# Former Marchon ICI Site, High Road, Whitehaven

# Proposal for Residential Development - (App ref 4/21/2432/0F1)

Highways Position Statement - August 2022

**Appendix C:** Refuse Vehicle Swept Paths

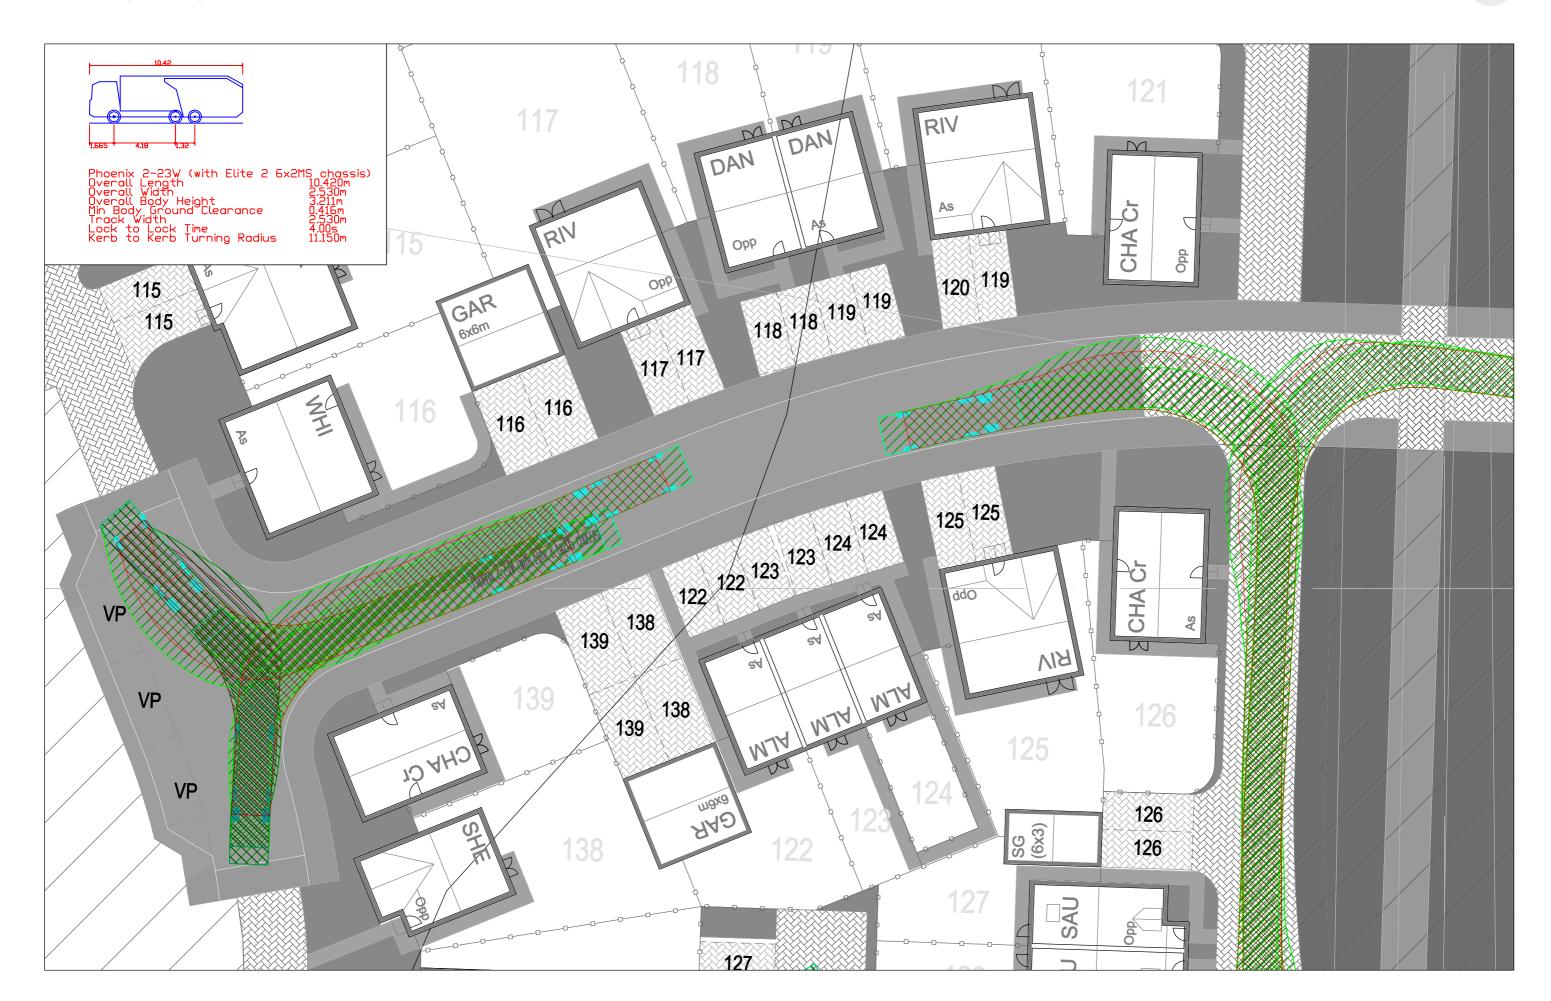
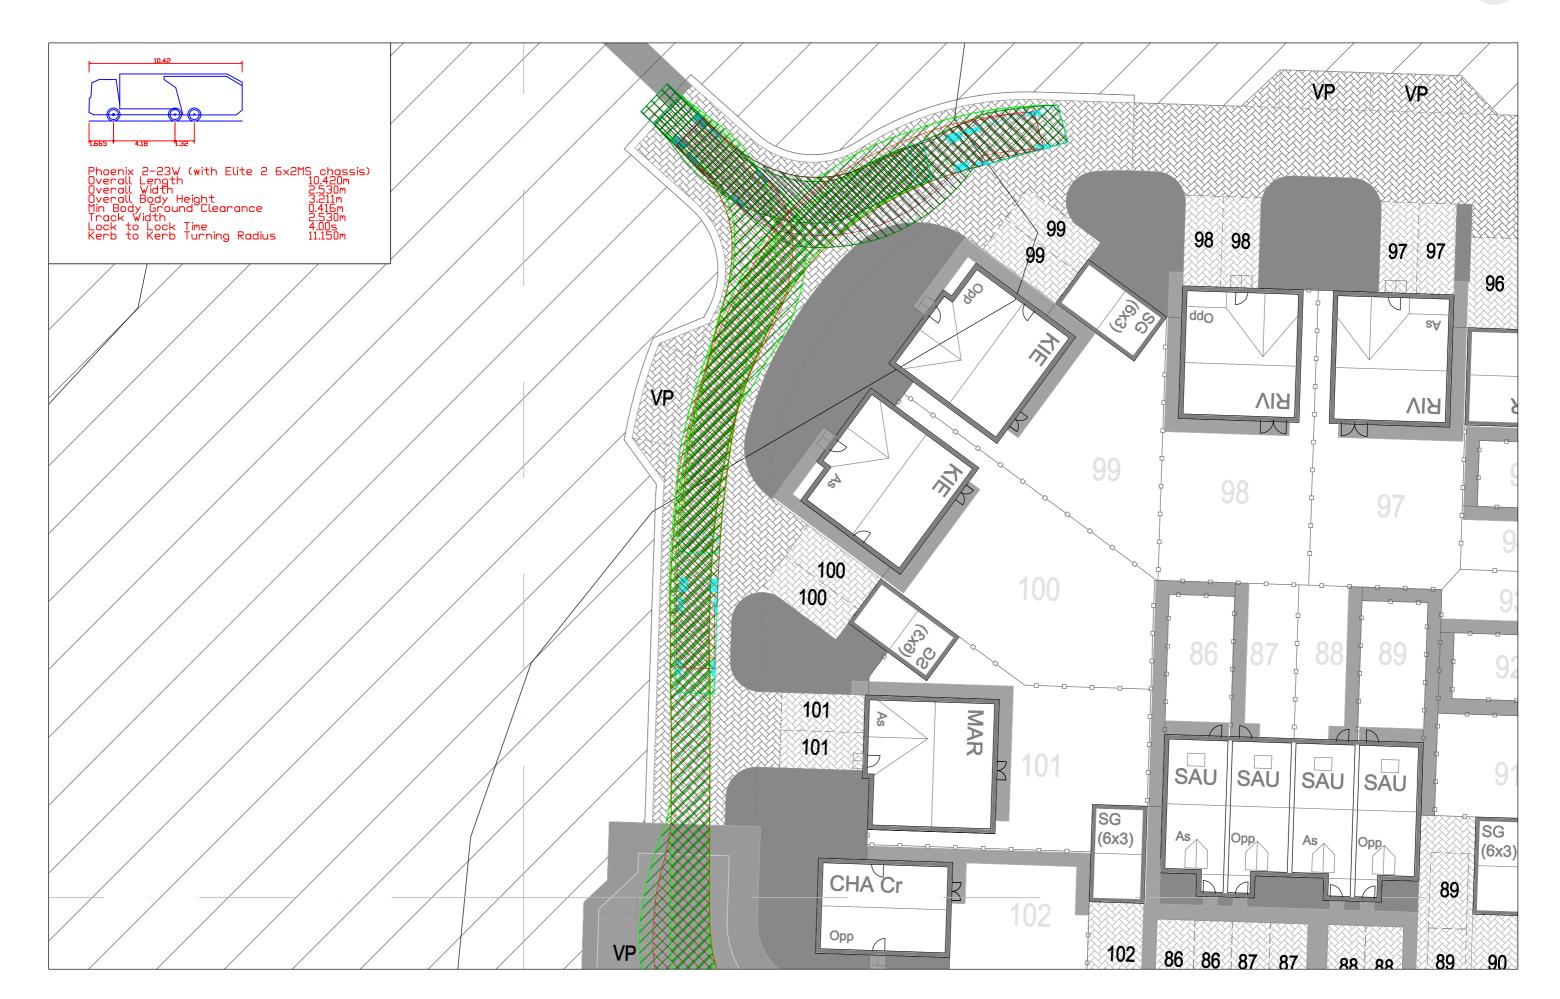
- 2.5 CCC have requested that swept paths of refuse vehicles are provided at the turning heads on the private drives. Typically refuse vehicles would not enter private drives with residents moving bins to the end of the drive on collection day or refuse operators walking into the drive to collect the bins. All but one of the private drives in the proposed development has been designed on this principle.

- 2.6 The exception is the private drive which comes off the southern access road adjacent to Unit 126 which is longer than the others and serves more units. The swept path of a refuse vehicle using this private drive is included in Figures A and B in **Appendix C**. The design of this private drive has been modified in the revised site layout to accommodate the swept path.

- 2.7 **Appendix C** also includes refuse vehicle swept paths at the other turning heads in the Phase 1 development. These would however be part of the adopted highway and not private.

- Agreed there is no need for refuse vehicles to access the private shared driveways.
- The redesign of the long driveway adjacent to Plot 126 is noted and the swept path shows the manoeuvre can be accommodated. Please note that the applicant has to be satisfied that the refuse operator is prepared and has agreed to access this private shared driveway and also that the driveway will have to be constructed to a suitable standard of construction for the extra vehicle loading but it will remain private.

$\textbf{Appendix D:} \ \ \textbf{B5345} \ \ \textbf{Meadow View / Ginns to Kells Road Junction}$

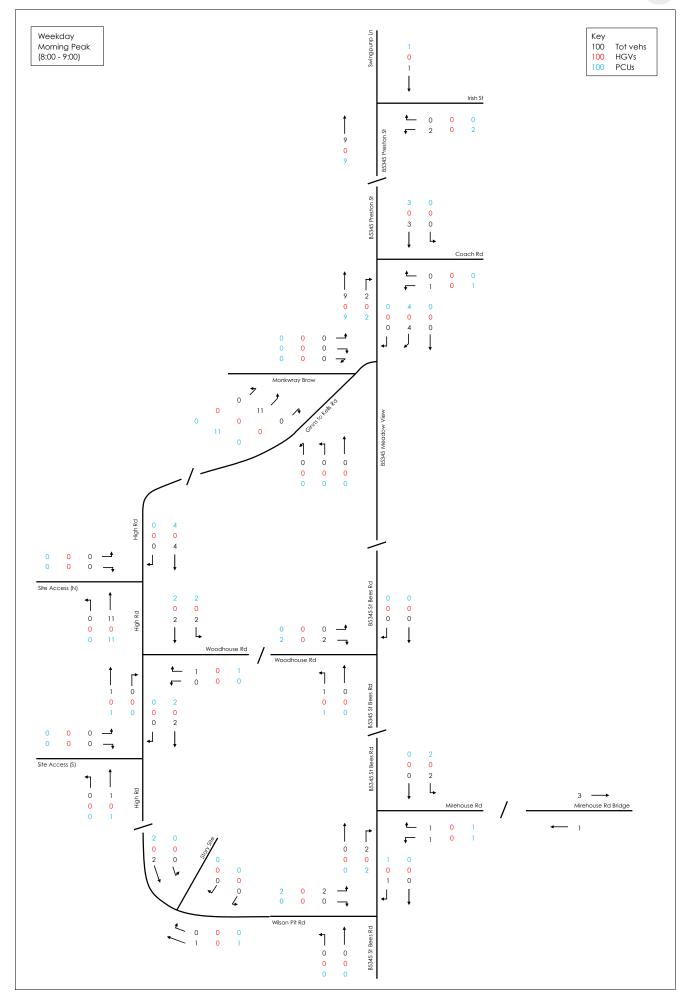
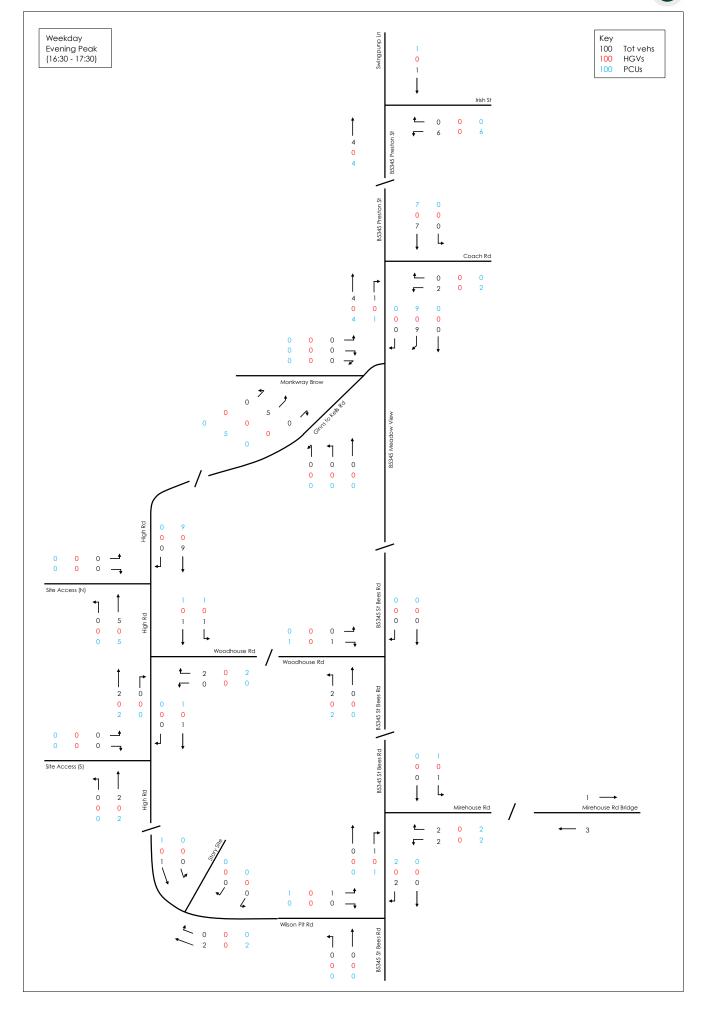
- 3.2 The Transport Assessment identified the potential to provide traffic signals at the Meadow View / Ginns to Kells junction to accommodate traffic from the Marchon site and other developments in south Whitehaven.
- 3.3 In their comments CCC express concerns over this proposal particularly in the context of the interaction with car parking on Meadow View.

- 3.4 We discussed this issue specifically with CCC officers during the Teams meeting on 19<sup>th</sup> February 2022. Following the meeting we provided CCC with LINSIG models which demonstrated that the traffic signals could be implemented without queues on Meadow View extending to the parked vehicles. The potential to instal a queue detector on Meadow View was also discussed with officers which would provide further assurance that queues would not extend to the parked vehicles.

- 3.5 For completeness the LINSIG model output and drawing of the signalisation scheme are included in **Appendix D** to this note. This information was also included in Appendix I of the original Transport Assessment the additional information provided to CCC following the Teams meeting was the digital file of this LINSIG model.

- The Linsig model shows that signalising this junction will work in theory. The LHA accept the proposed banned movement is necessary and that this will not cause a material impact on the network. Further detail and modelling and the consideration of queue detection will be required in due course as part of the detailed design.
- Please be aware of the TRP process and timescale that will be required to make the banned turn legal. The TRO will need to be in place before the junction can be commissioned.
